Access Compliance Report

Public Rights-of-Way

Intersection ID: 32085	Main Street: JERPOINT_ABBY_DR	Cross Street: LISMORE_CASTLE_CT	Location: SE
ADA ID: 23D41408B9B3	Ramp Type: PerpDiag	Initial Pass/Fail: Fail	Overall Compliance: No
Codes/Mitigation Info/Possible Solution		Field Measurements/Component Compliance	
Severity Score: 8.75

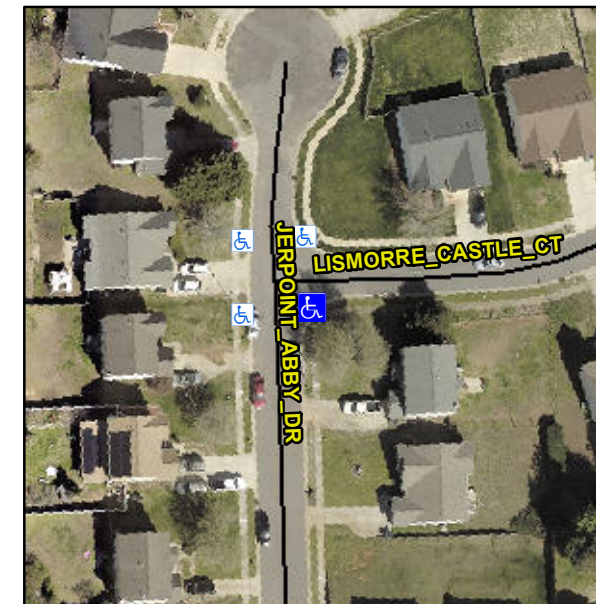
Compliance	Description	Data	Compliance	Description	Data
N/A	Ramp Length (in)	47.0	Yes	Ramp Slope (%)	7.7
No	Ramp Width (in)	40.0	Yes	Ramp XSlope (%)	0.1
N/A	Flare Type LT	N/A	N/A	Flare Type RT	N/A
N/A	Flare Slope LT (%)	N/A	N/A	Flare Slope RT (%)	N/A
N/A	Flare Traversable LT?	N/A	N/A	Flare Traversable RT?	N/A
N/A	Landing Length (in)	N/A	N/A	DWS Provided?	N/A
N/A	Landing Width (in)	N/A	N/A	DWS Contrast?	N/A
N/A	Landing Slope (%)	N/A	N/A	DWS Length (in)	N/A
N/A	Landing X Slope (%)	N/A	N/A	DWS Full Width?	N/A
N/A	Landing Curb? (Y/N)	N/A	N/A	DWS Offset (in)	N/A
N/A	Shared Landing?	N/A			
N/A	Gutter Ponding?	N/A	N/A	Gutter Slope (%)	N/A
N/A	Gutter Lip Ht (in)	N/A	N/A	Gutter X Slope (%)	N/A
N/A	Painted X Walk1?	No	N/A	Painted X Walk2?	No
	X Walk 1 Direction	To N		X Walk 2 Direction	To W
N/A	X Walk 1 Width (in)	N/A	N/A	X Walk 2 Width (in)	N/A
	X Walk 1 Slope (%)	4.6		X Walk 2 Slope (%)	0.6
	X Walk 1 X Slope (%)	0.0		X Walk 2 X Slope (%)	1.2

Remove & Replace Curb Ramp With Two New Directional Ramps or Equivalent.
